**ASHLAND PLANNING DEPARTMENT
PRE-APPLICATION CONFERENCE
COMMENT SHEET**
October 15, 2025

SITE: 319 West Street
APPLICANT: George Menedes et al
REQUEST: Physical & Environmental
Constraints Review Permit for Hillside
Development, Exceptions

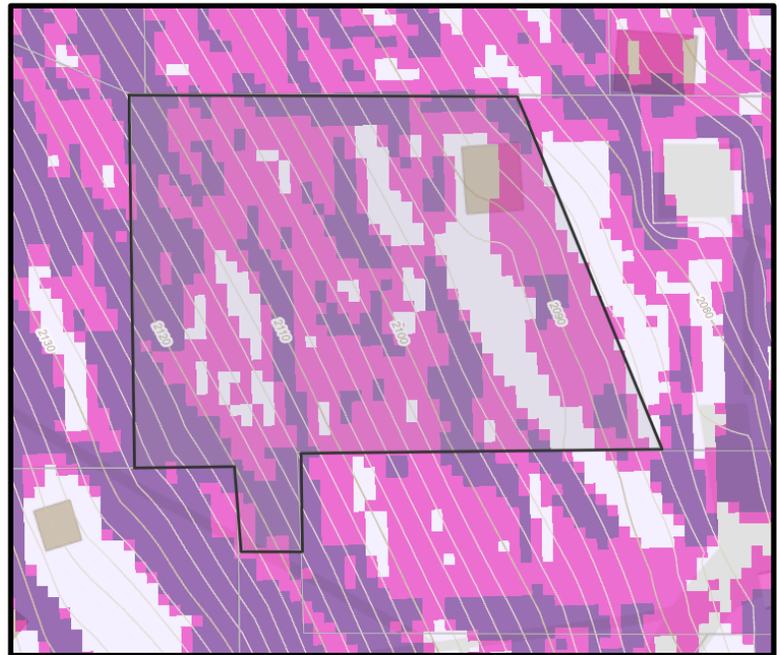
The property is partially 'severely constrained' (slopes greater than 35%). On the image to the right (generated by City GIS) the dark magenta/purple are slopes greater than 35%, and light magenta showing slopes greater than 25%.
